From: ben whitby <benwhitby15@yahoo.co.uk>
Sent: 03 August 2010 10:52
To: Peter Barnett
Cc: Rod Eason
Subject: 21 Adur Drive Shoreham - Rear porch & extension
Attachments: 02 Proposed Rev A.pdf

Project:
Proposed Rear Extension & Front Porch At:
21 Adur Drive
Shoreham By Sea
West Sussex
BN43 6PN

Drawing title:
Plans & Elevations As Proposed

Scale: 1:100 1:50
Paper size: A1
Date: 5.7.2010
Drawn: BJW
Drg. No. 02
Rev'n A

East (Front) Elevation

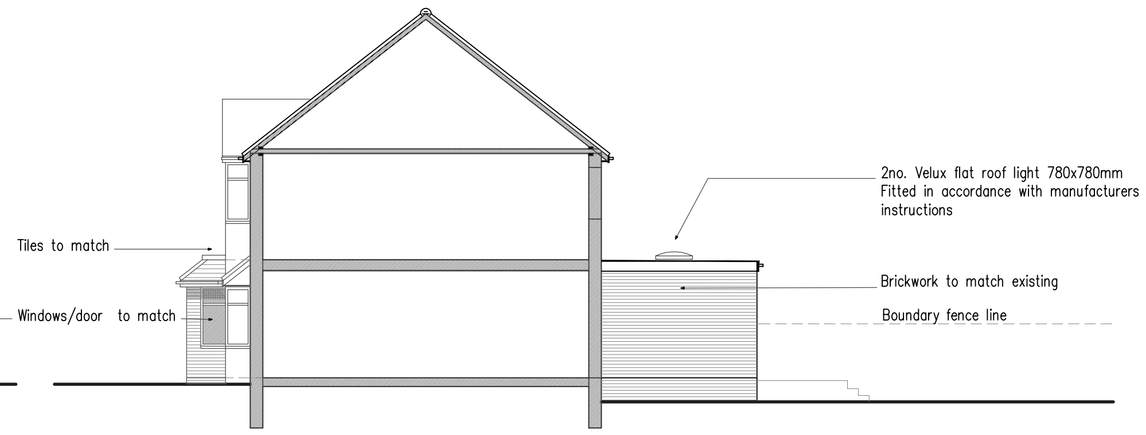
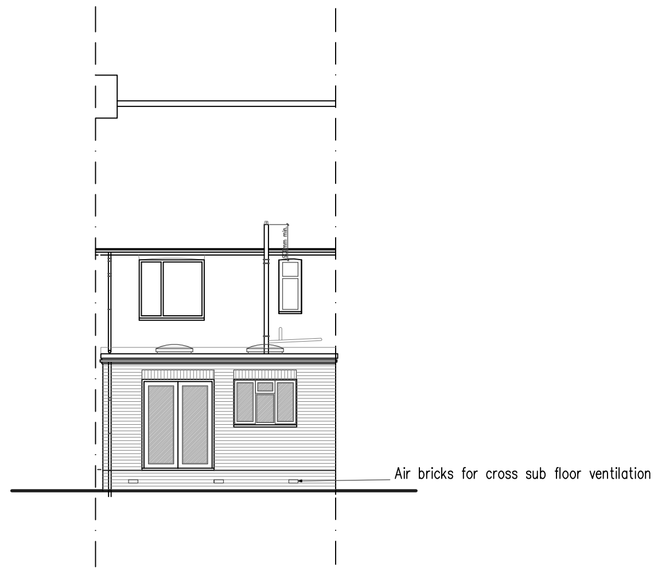
1) Porch roof has been reduced to 3m height (within pd rights) and its style has been altered so as to be softer & less bulky and to match others in Adur Drive - please see no. 15 & 18 on streetview. The eaves are reduced also as to not encroach on boundary.

2) The rear extension flat roof has been reduced in height by 200mm to be more acceptable as you mention in your letter.
To step the extension down would restrict access for the wheelchair bound visiting the family and any future occupiers.
It is understood that both neighbours intend to add a rear extension to the same depth as our proposal in the very near future.

A	3.8.10	Height of rear extension reduced by 200mm
A	3.8.10	Height of porch reduced in keeping with similar in street
